Date: January 14, 2000
Subject: QZ99-043 Part A Section 10: Dam Safety Assessment of the Mt. Nansen Tailings Dam

BYG Tailings Dam, Mount Nansen, YT - Project Data Review Report

INDIAN AND NORTHERN AFFAIRS
WATER RESOURCES DIVISION
BYG Tailings Dam, Mount Nansen YT - Project Data Review Report

TAILINGS DAM - PLAN VIEW
Figure 1

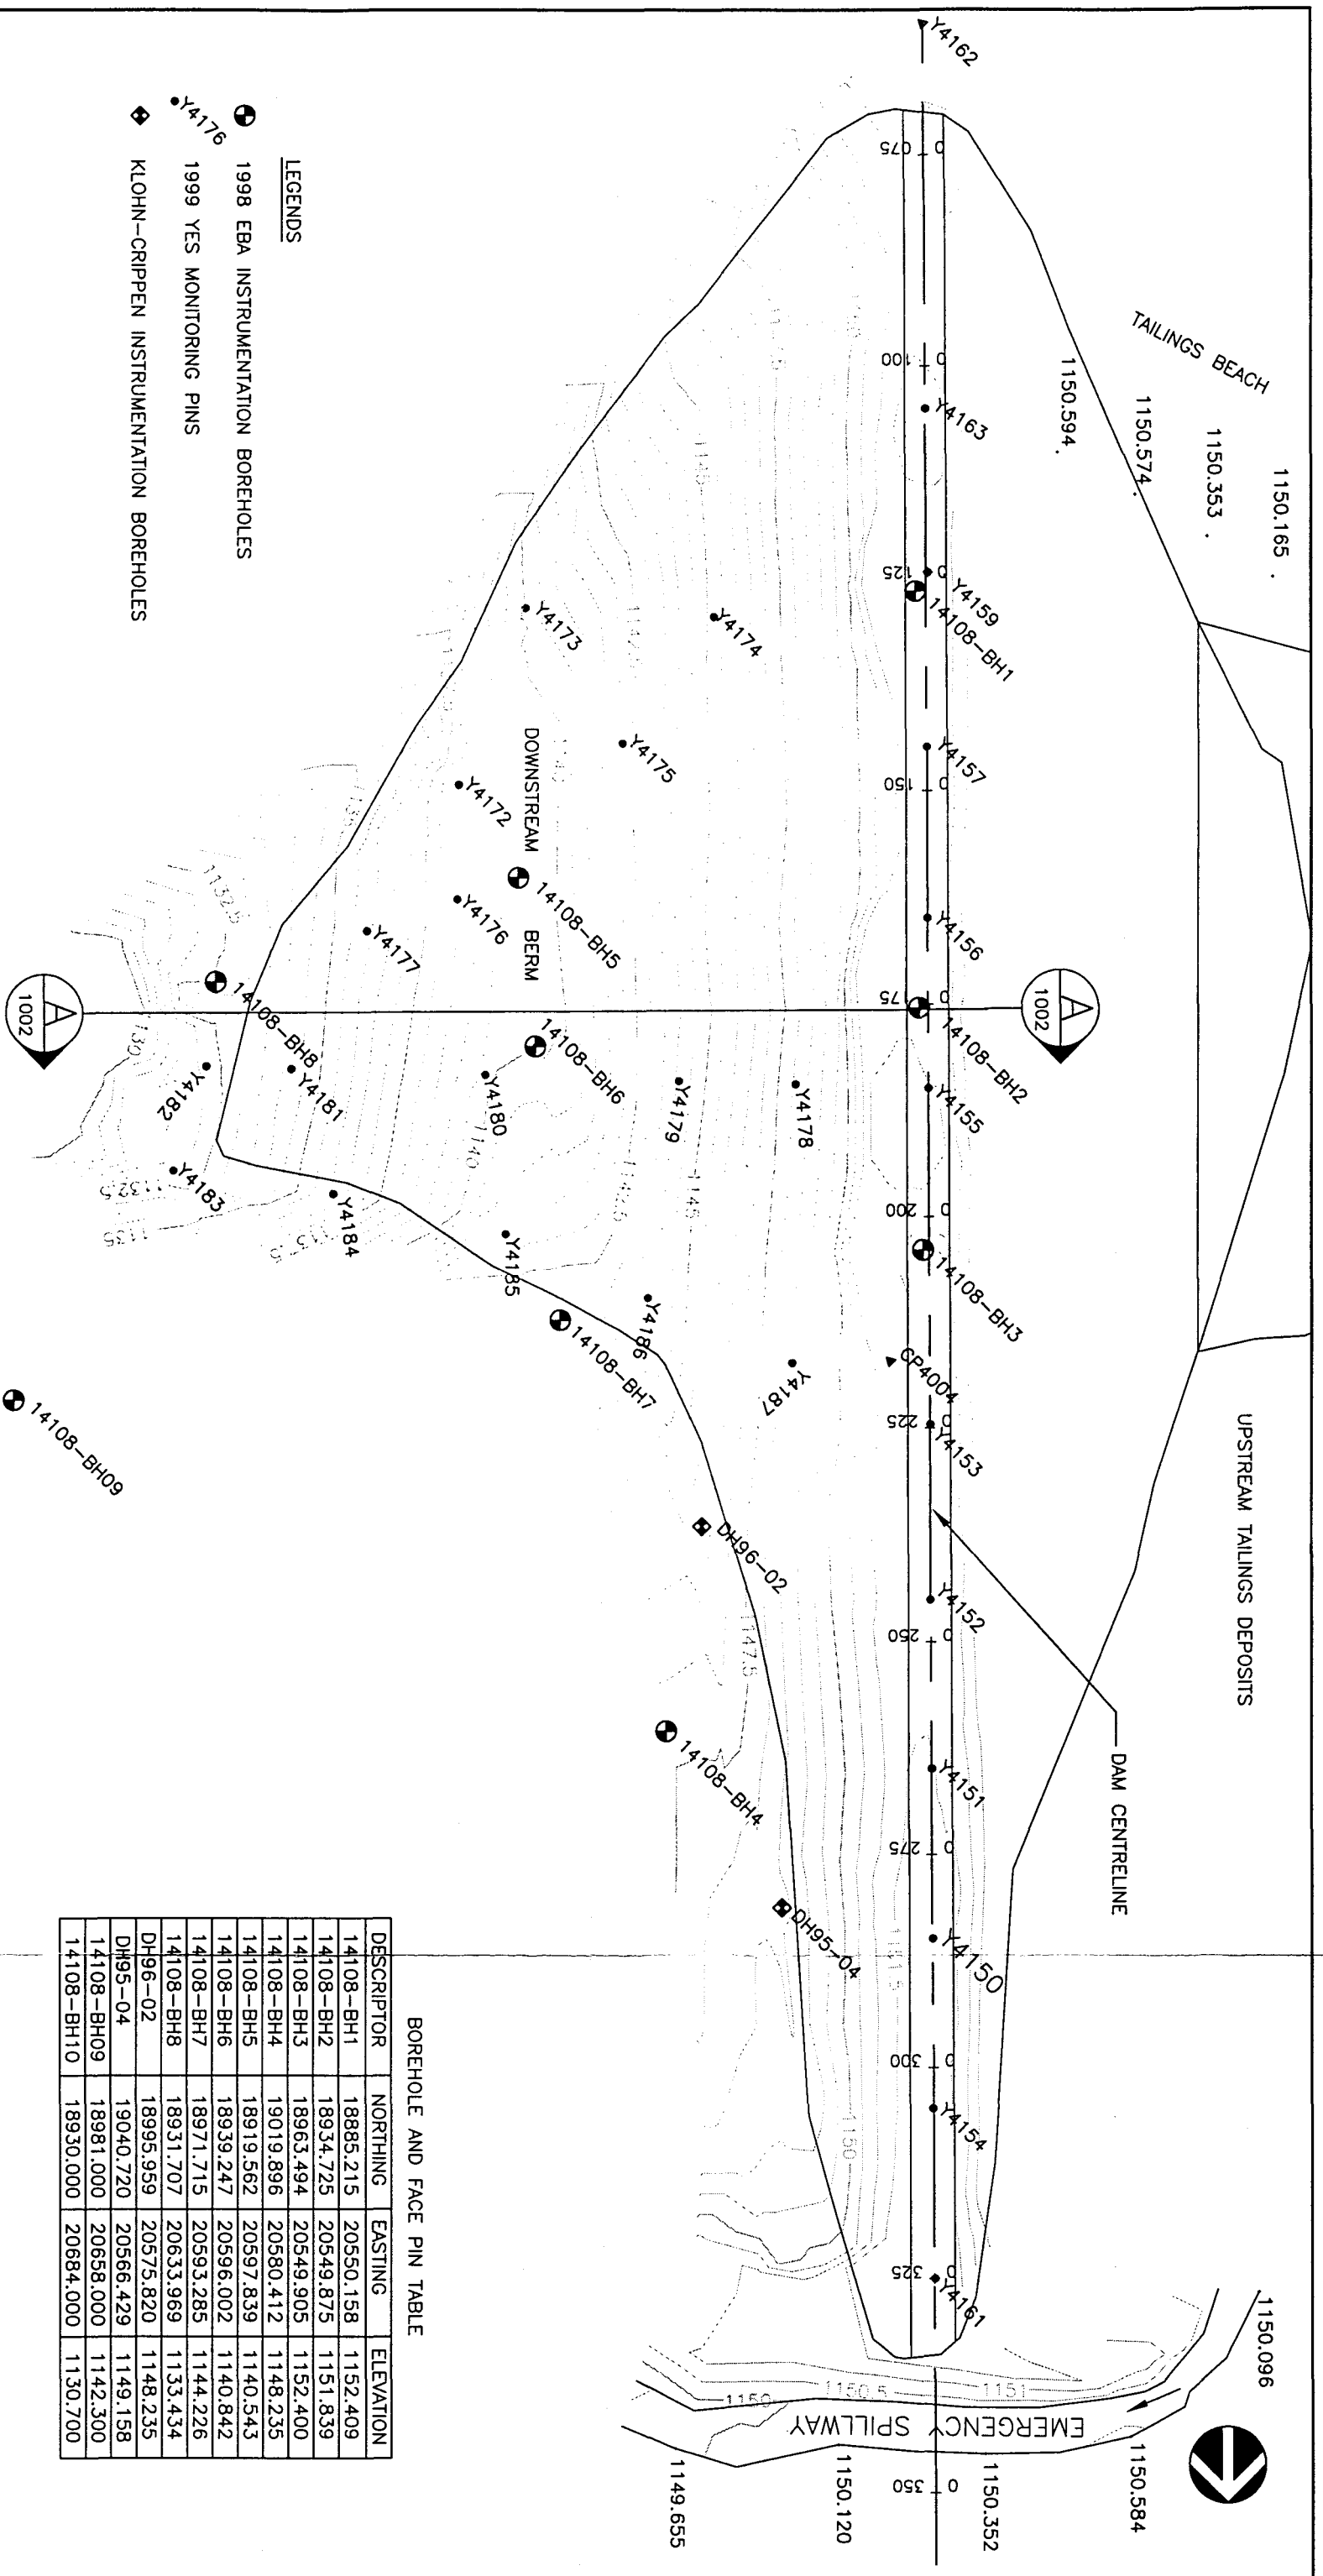
The original invert elevation of the emergency spillway inlet was set at El. 1149.7 m at its upstream end. However, the recent survey by Yukon Engineering Services (YES 1999) conducted on October 28-31, 1999 indicated that the present invert elevation is at El. 1150.6 m. Figure 1 presents the Main Tailings Dam in plan based on this recent survey. To date the highest recorded pond level was at El. 1150.13 m on September 18, 1999, and no surface water has been spilled over the emergency spillway. Thus, the higher invert elevation obtained by the October 1999 survey is consistent with the recorded pond levels.

EBA reviewed records of those thermistors installed in 1998 at 10 boreholes (see Figure 1 for their locations), and reported in their data review (Table 2 in EBA 1999a) that the foundation thaw depth within the dam proper (Boreholes BH #1 to #3, #5, #6 and #8) ranges from about 0.75 m at Borehole BH #1 to a maximum depth of 3.6 m to 4.9 m at Borehole BH #3. The concerns of permafrost degradation of the dam foundation are elaborated in Section 5.1.

Limit-equilibrium stability analyses were carried out for the downstream slope of the maximum dam section based on the geometry of the dam and its downstream berm as shown on Figure 1. Salient features of the stability analyses including the soil properties (also summarized in Table 1), piezometric levels, failure surfaces and static safety factors are summarized in Figure 7. As shown in Table 1, two sets of strength parameters were used: (1) design strength set used in the design report (Klohn-Crippen 1995); and (2) reduced strength set, used to investigate the possible effect of reduced strength.

BYG TAILINGS DAM
 DAM SAFETY ASSESSMENT
 TAILINGS DAM -
 STABILITY ANALYSES
 Figure 7

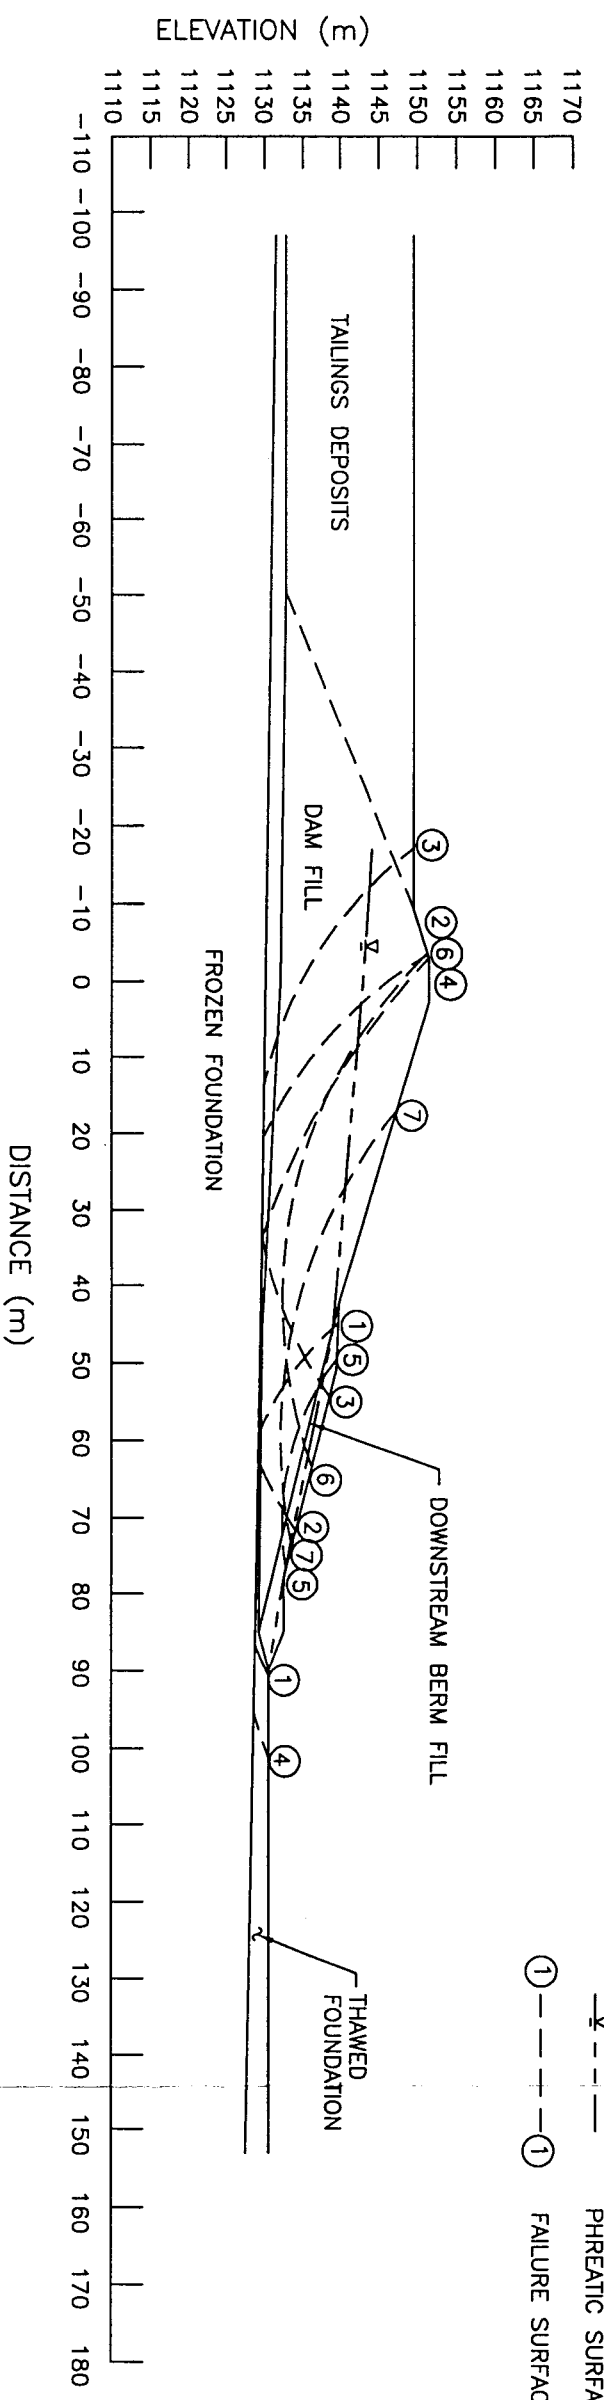
Table 2 summarizes the static safety factors against downstream slope instability. As shown in the table, the static safety factors of the downstream slope are in a range of 1.5 to 3.0 (with design strength), with a minimum value of about 1.5 near the surface of the downstream berm slope. With the reduced strength, the corresponding static safety factors are in a range of 1.3 to 2.5, with a minimum value of about 1.3 near the surface of the downstream berm slope. These preliminary results indicate that the general downstream slope appears to be stable. However, potential seasonal and local conditions could influence the actual static safety factors, and should be further examined closely in order to ensure the dam stability in the long-term condition.

Figure 8 - Tailings Dam - Seepage Pump-back Rate Monitored by Flow Meter

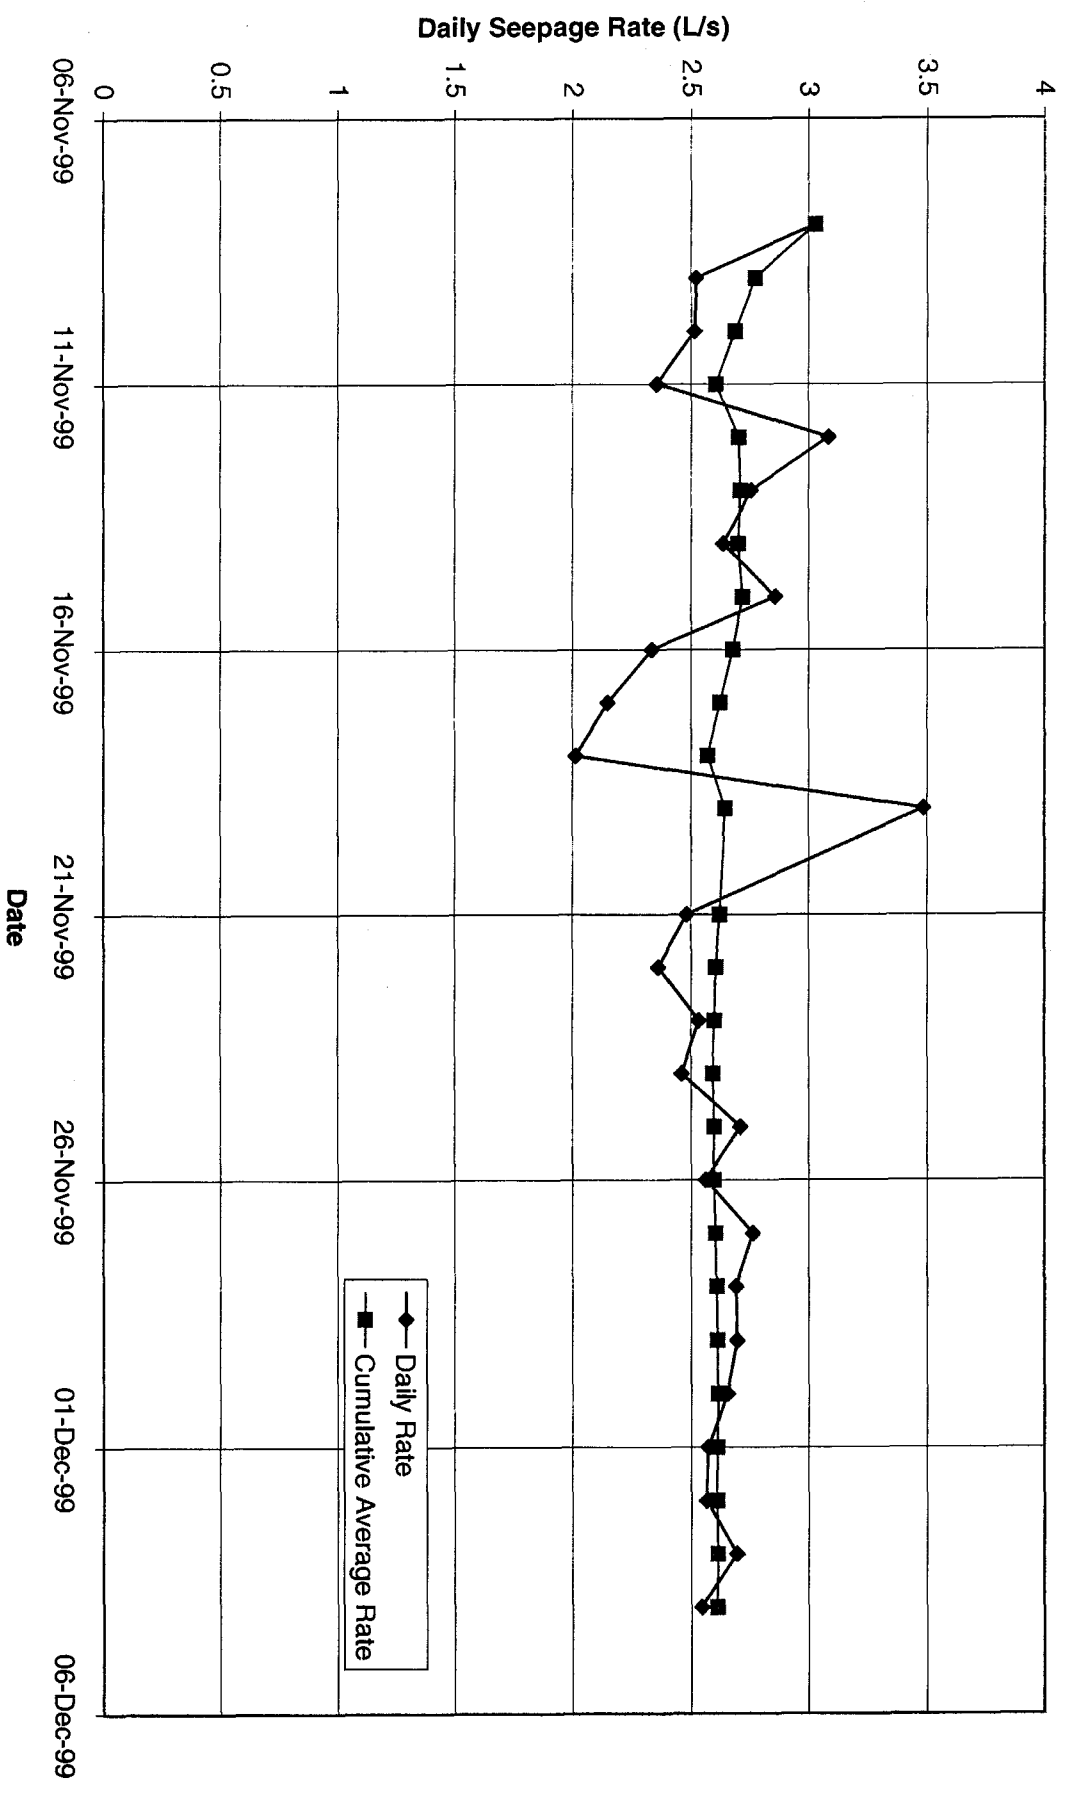
A flow meter was installed in November 1999 to measure the seepage returning from the Seepage Recovery Pond to the tailings pond near the discharge end of the pump-back line (EBA 1999c). The flow rates calculated from both the daily and cumulative records from November 3 1999 to December 4, 1999 are plotted on Figure 8. The former represents the measured daily pumping rate, while the latter reflects the average pumping rate up to a specific date. EBA (1999c) also reviewed BYG's seepage records from March 29, 1999 to November 2, 1999 and concluded that a seepage pump-back rate in the range of 2.6 l/s to 2.9 l/s probably reflects the seepage condition not significantly affected by snowmelt or precipitation. This monitored seepage rate is about one order of magnitude higher than the value of 0.2 l/s estimated in the design report (Klohn-Crippen 1995). The potential reason for this difference is the fact that throughout the life of the tailings impoundment high pond levels have been maintained. Thus, the tailings beach is of insufficient width to act as the main seepage barrier as envisaged in the original design.
